## CITY COUNCIL AGENDA

Tuesday, June 2, 2026, at 7:00 p.m.

### SYNOPSIS OF PROFESSIONAL STAFF COMMENTS FOR PLANNING COMMISSION & CITY COUNCIL

**Gregory Mahloch (Owner)/Joseph Gomez, Belcaro Development (Subdivider)/TD2 (Agent)  
Revised Preliminary Plat & Final Plat**

Sheet Title  
**SPRINGFIELD, NEBRASKA**  
**SARPY COUNTY**  
**FINAL PLAT**  
 Sheet Number

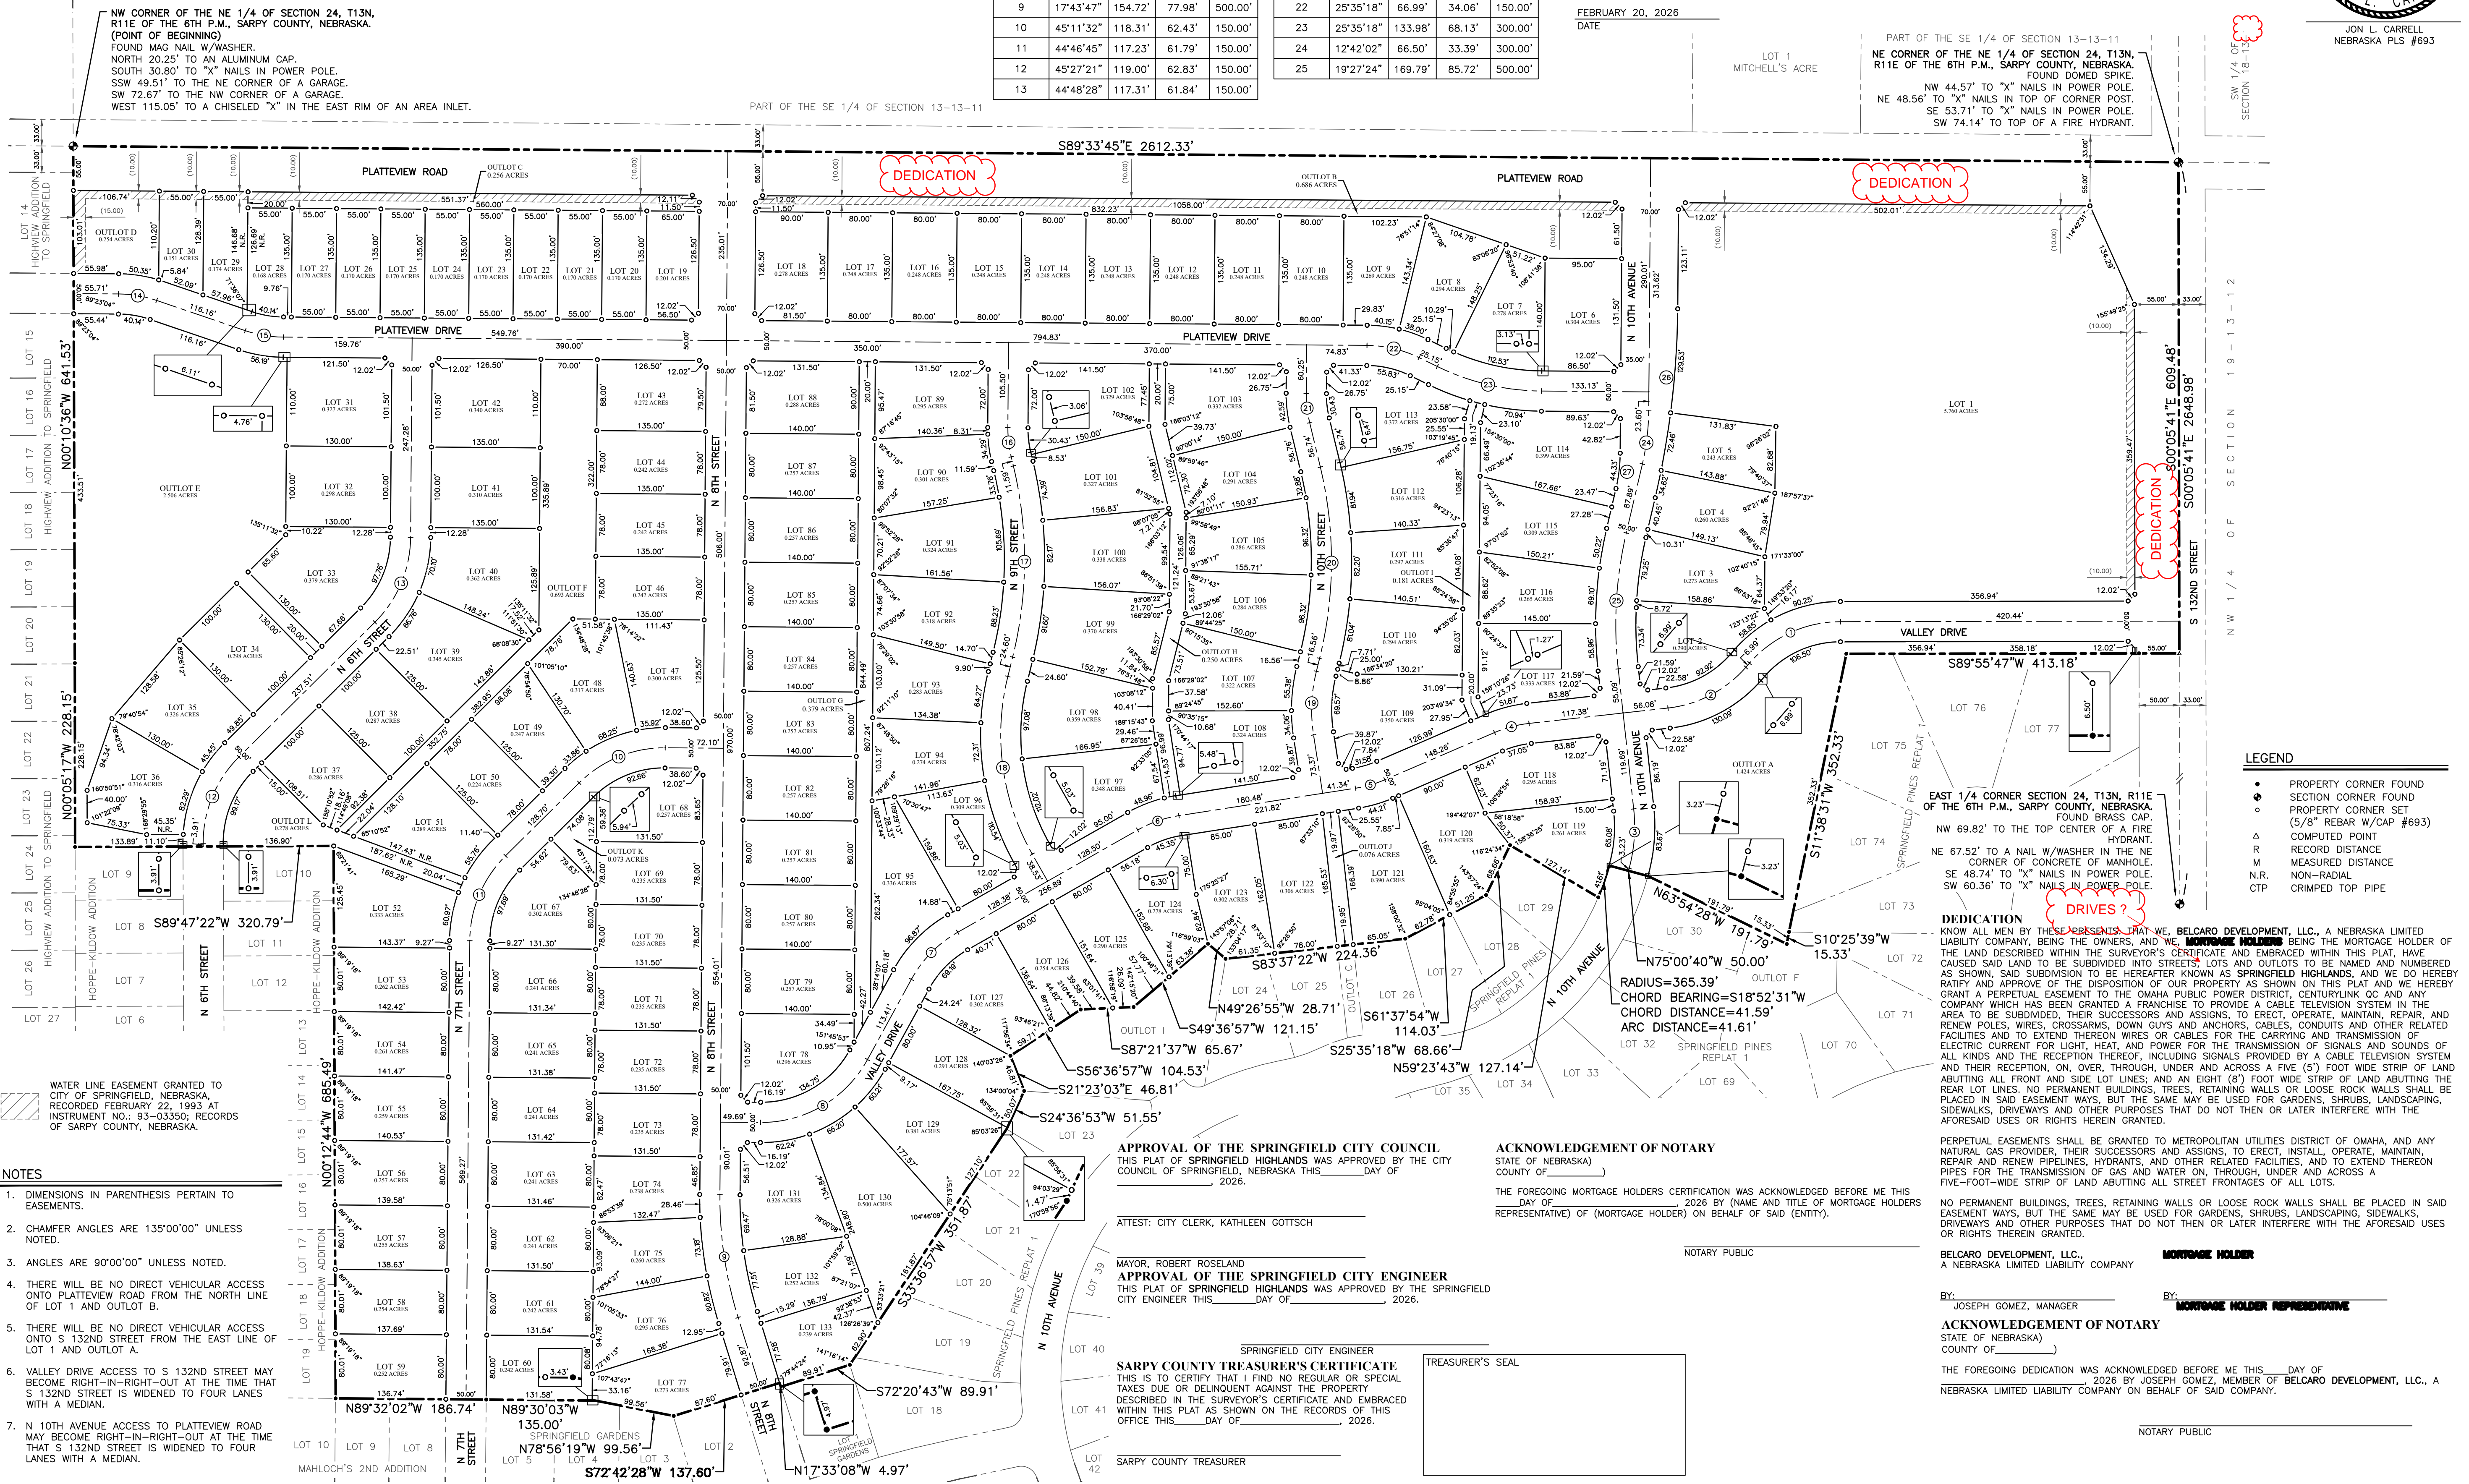
1. Add "Dedication" on Main Street and 132<sup>nd</sup> Street.
2. Add Range Number to the section by the Land Surveyor's stamp on drawing.
  - a. Currently, the plat shows "SW ¼ of Section 18-13-"
3. Add "Drives" in the dedication block.
  - a. "...BEING THE MORTGAGE HOLDER OF THE LAND DESCRIBED WITHIN THE SURVEYOR'S CERTIFICATE AND EMBRACED WITHIN THIS PLAT, HAVE CAUSED SAID LAND TO BE SUBDIVIDED INTO STREETS, DRIVES, LOTS AND OUTLOTS..."
